NL-04-1367

**Joseph M. Farley Nuclear Plant Units 1 and 2  
Response to Third Request for Additional Information Related to  
Request to Revise Technical Specifications - Containment Equipment Hatch**

**SNC Response to NRC Request for Additional Information**

Figure 1

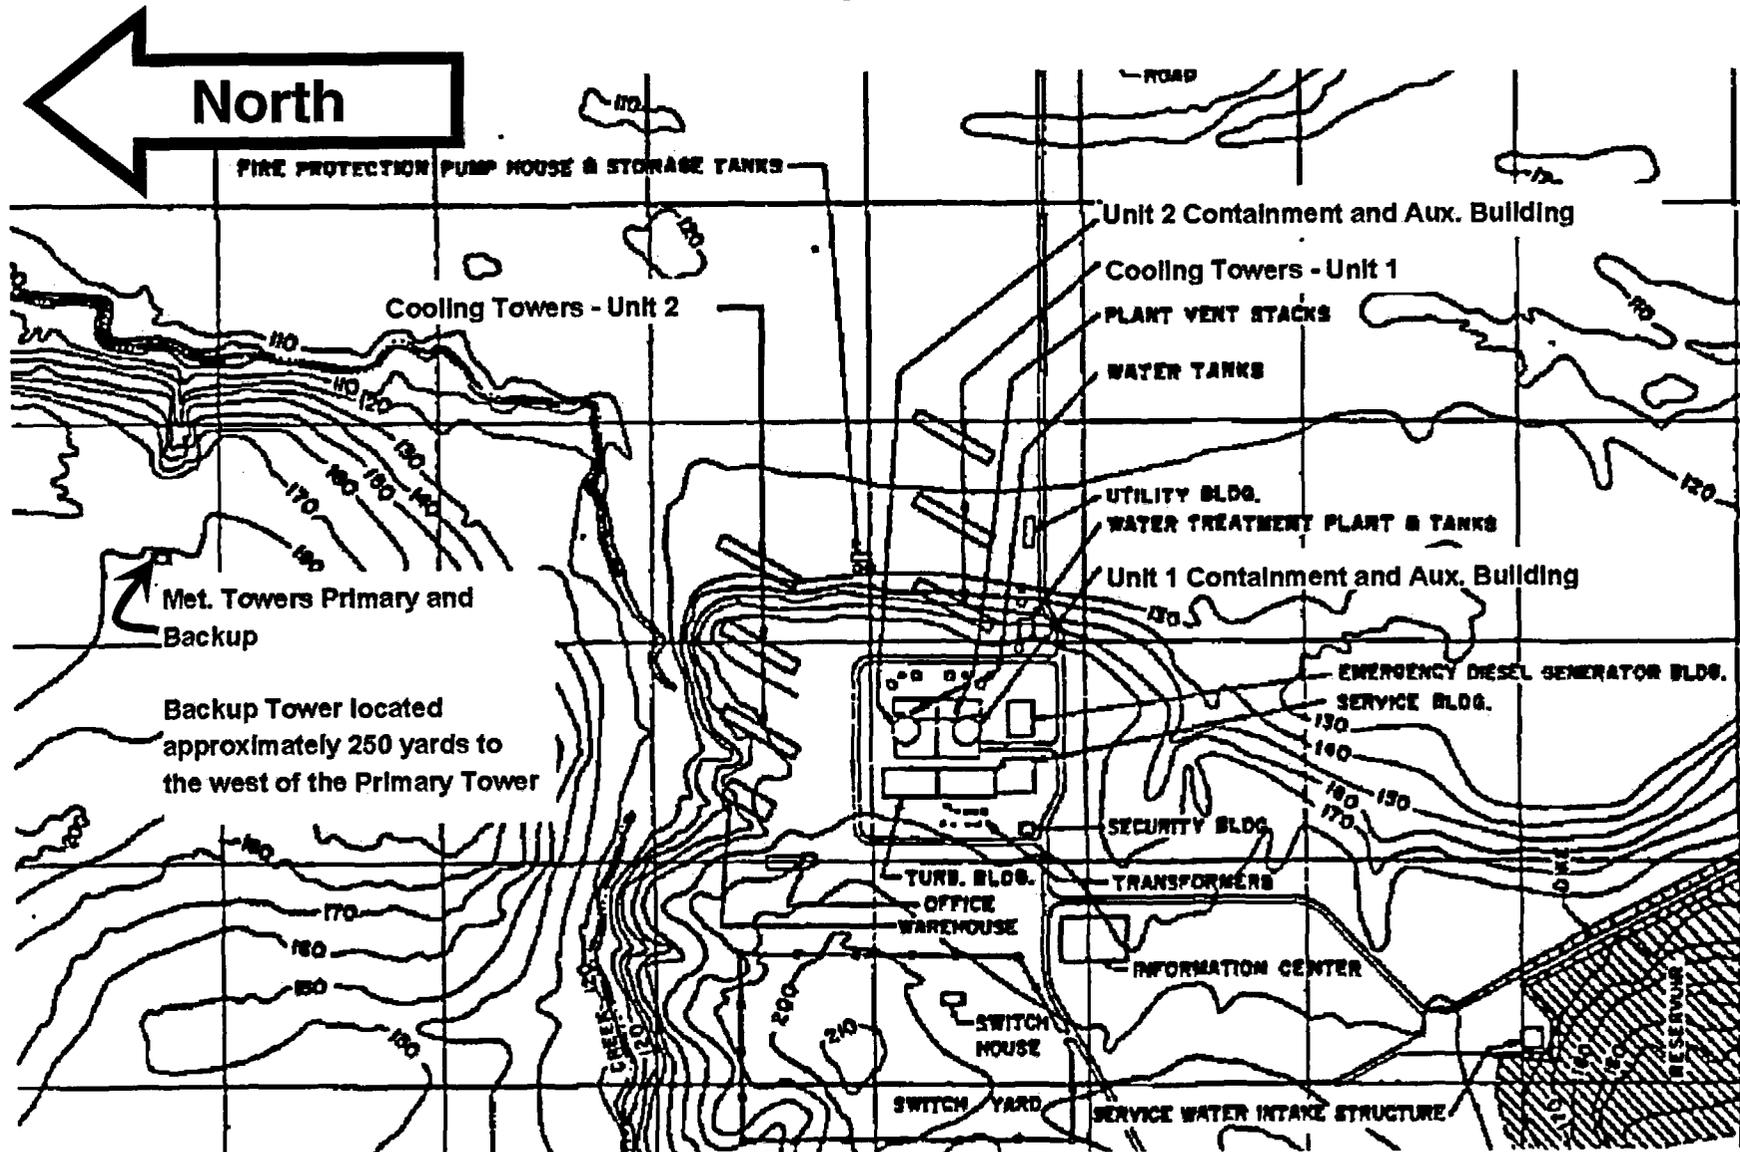
- a) Please provide a site plan for the Farley Nuclear Plant showing the locations of the reactor building complex, cooling towers, and primary and backup meteorological towers. Please also provide a description of the primary and backup meteorological tower structures (e.g., structure type and dimensions, instrumentation boom length and direction, etc).

Figure 1 contains an excerpt of FNP FSAR Figure 2.3-27, "Plan Showing Site Topography and Plant Structures." The containment buildings, cooling towers, and meteorological towers, are identified on this drawing. Pictures and descriptions of the primary and backup meteorological tower structures (e.g., structure type and dimensions, instrumentation boom length and direction) are provided in Figure 2.
